# CENTER FOR NUCLEAR WASTE REGULATORY ANALYSES

## NONCONFORMANCE REPORT

Project No. 20-01402-571

NCR No. 2002-10

Carbon Steel Mockup Specimen  
 CNWRA Drawing 20-01402-571-20 Rev. 01  
 All Dimensions  $\pm 0.010"$   
 unless otherwise specified  
 Note: Detail A on Page 2

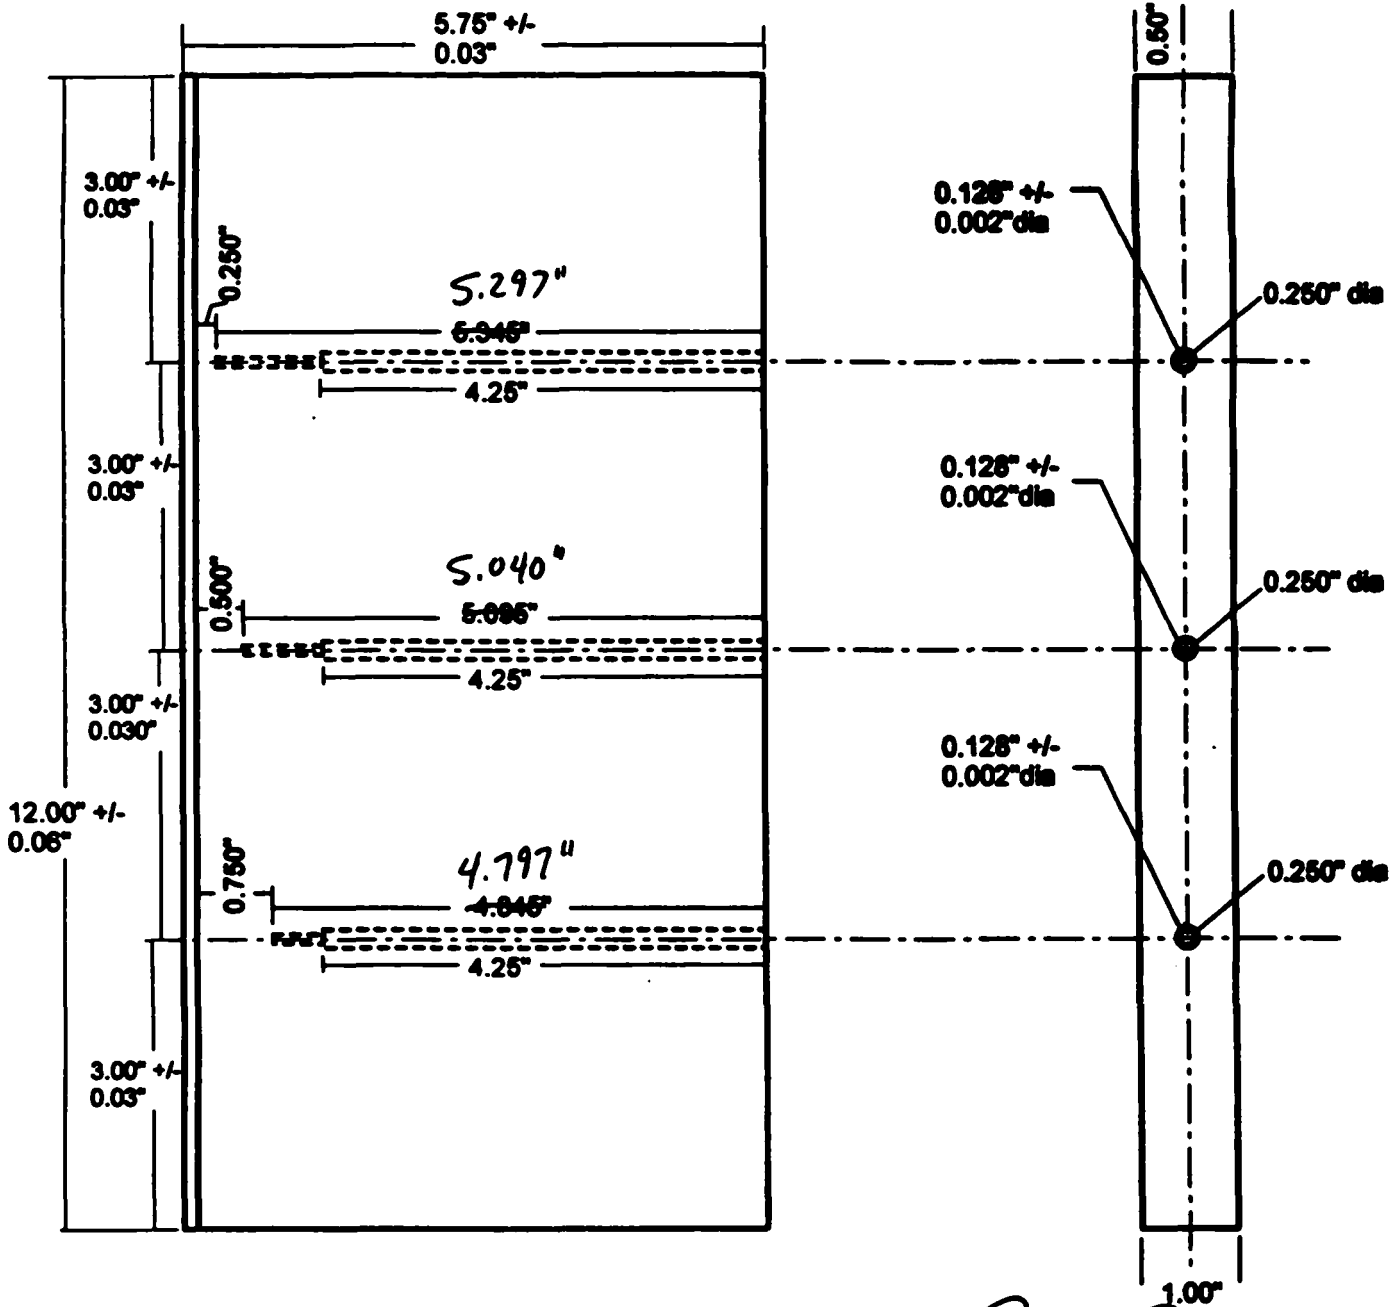
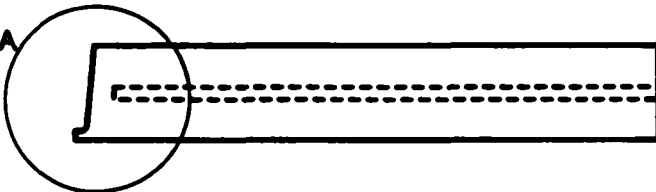
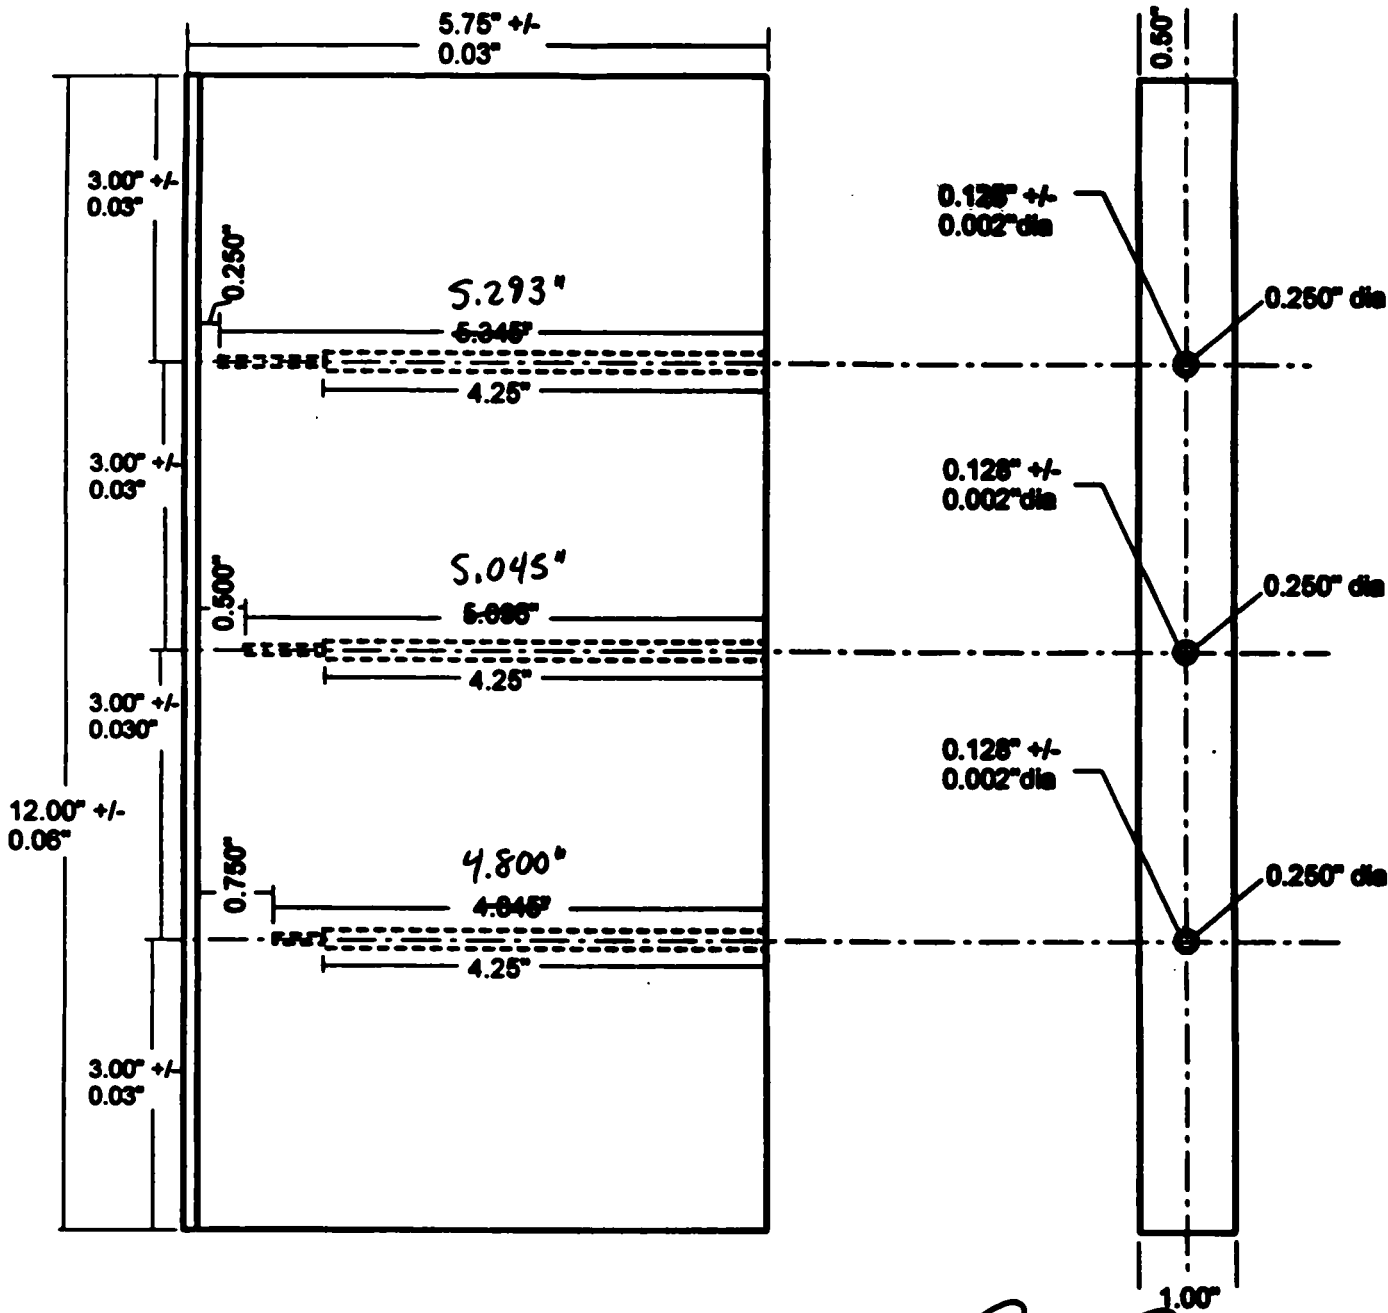
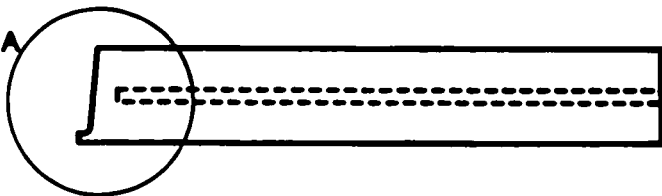
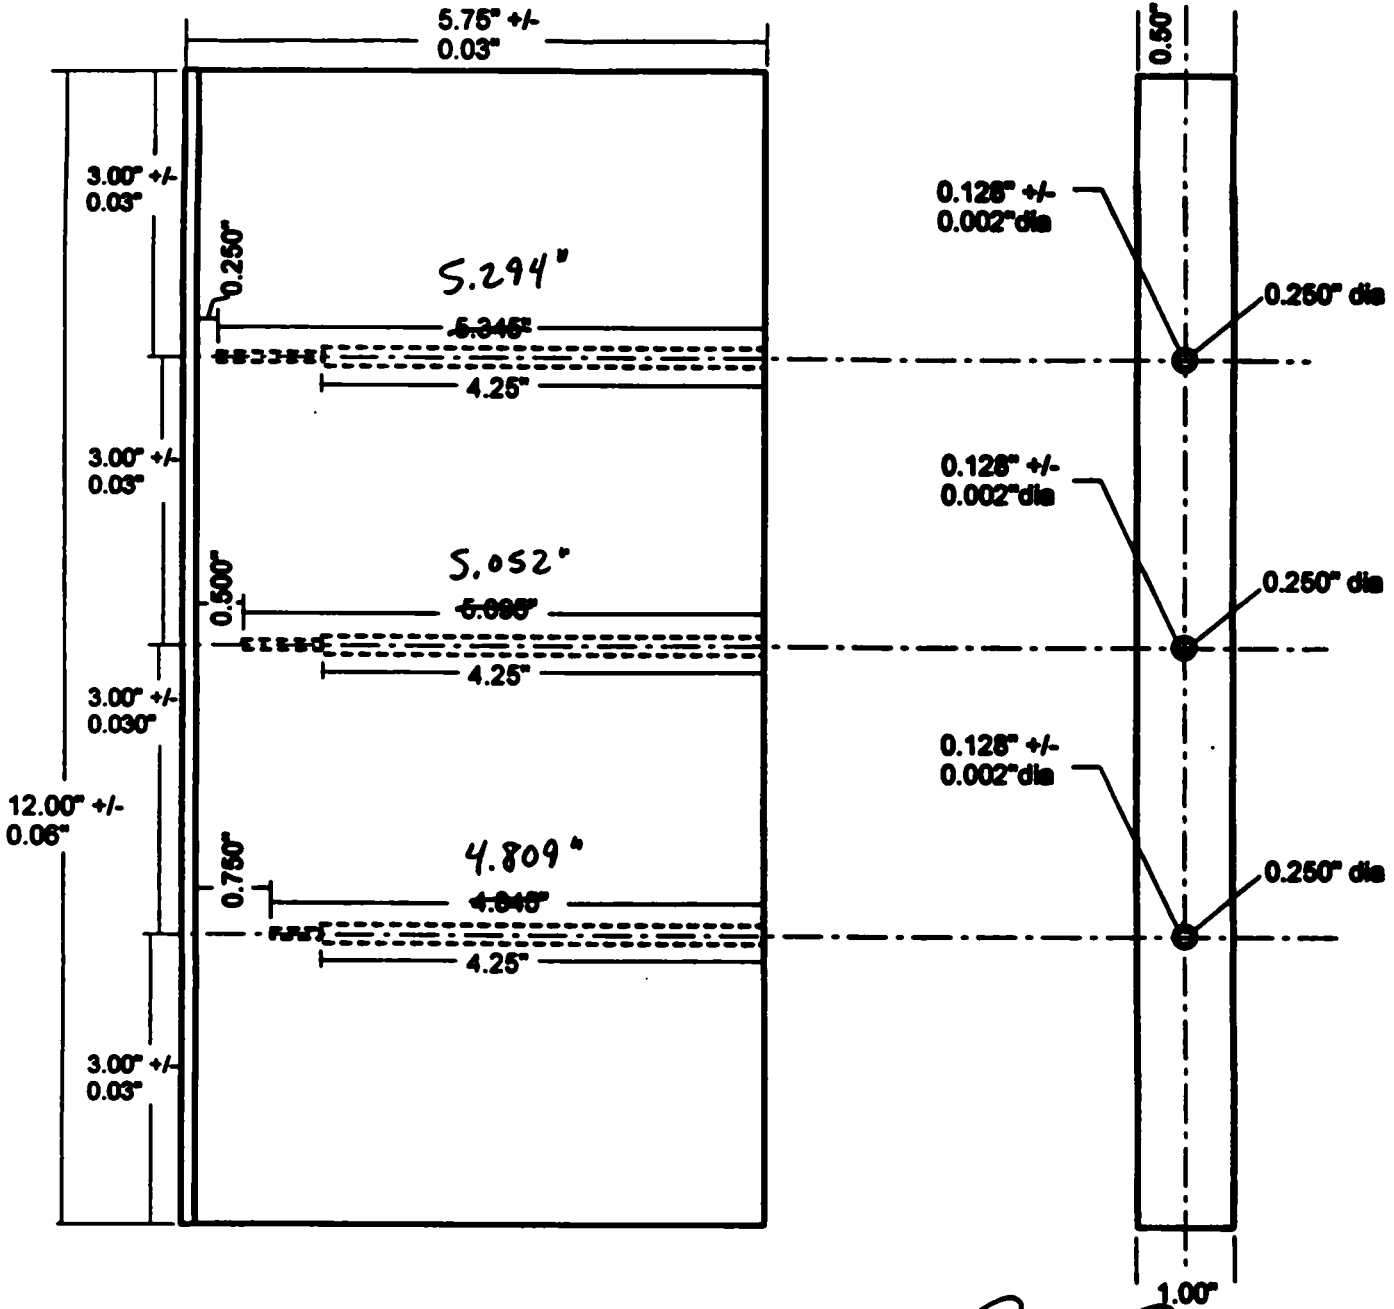
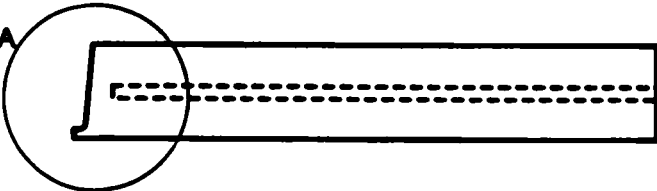
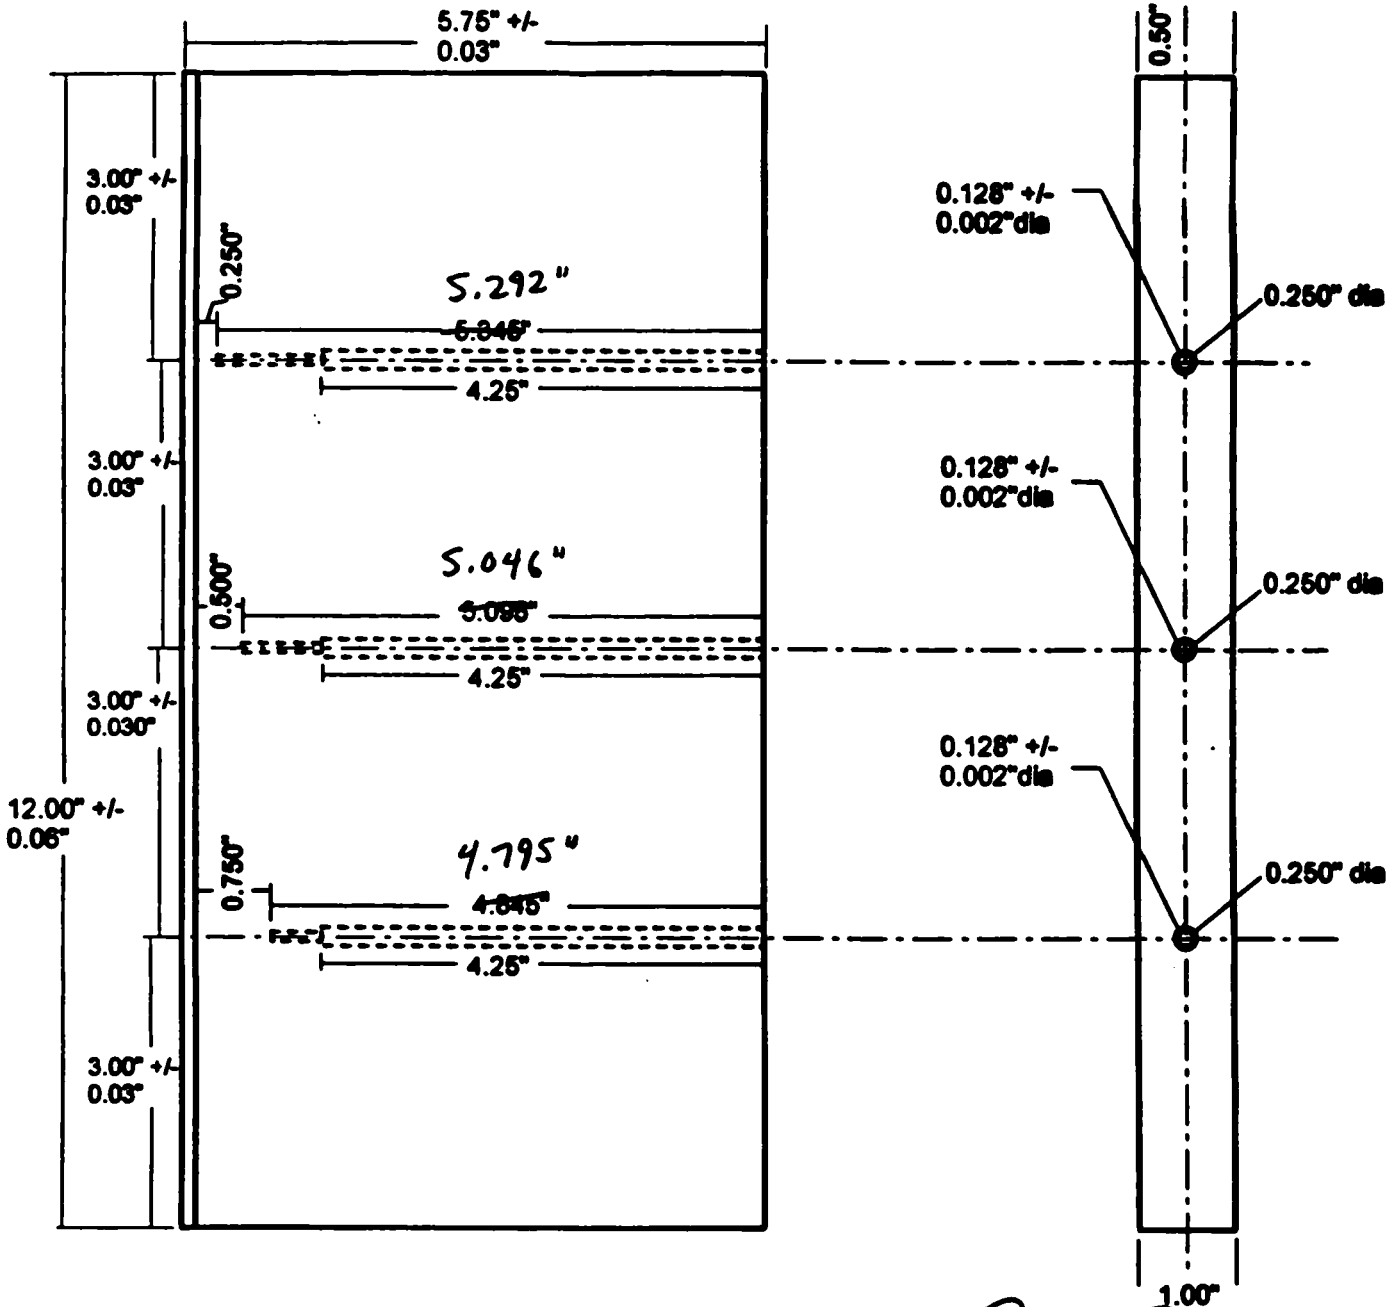
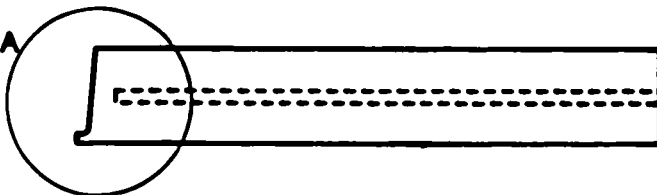
Dimensions of thermocouple holes provided in Drawing 20-01402-571-20 rev 01 are not correct. The depth dimension did not account for the 0.050" dimension of the weld preparation joint. Staff from Texas Toolmakers discovered error during machining of carbon steel mockup plates and informed Darrell Dunn via phone.

As a result of the error in the drawing the location of thermocouples was off by 0.50". This will not affect the welding process and the intent of the mockup plates, which was to approximate the amount of distortion that resulted from the welding process, will not be compromised.

The error in the drawing was discussed with staff at Texas Toolmakers (Mike Ridgway). Texas Toolmakers was instructed to complete machining using dimensions from weld preparation surface and ignore incorrect and redundant dimensions of thermocouple hole depths. Future drawings of weld preparation specimens will not include redundant dimensions. Actual depths of the thermocouple holes were recorded for each machined plate. Measurements made using calibrated micrometer Mitutoyo CD-6" P serial number 06-DC-5 Asset number 002438 calibrated March 25, 2002

Revise drawings to reflect the correct hole depth requirements.  
Record as-built measurements on future drawings. [Signature]
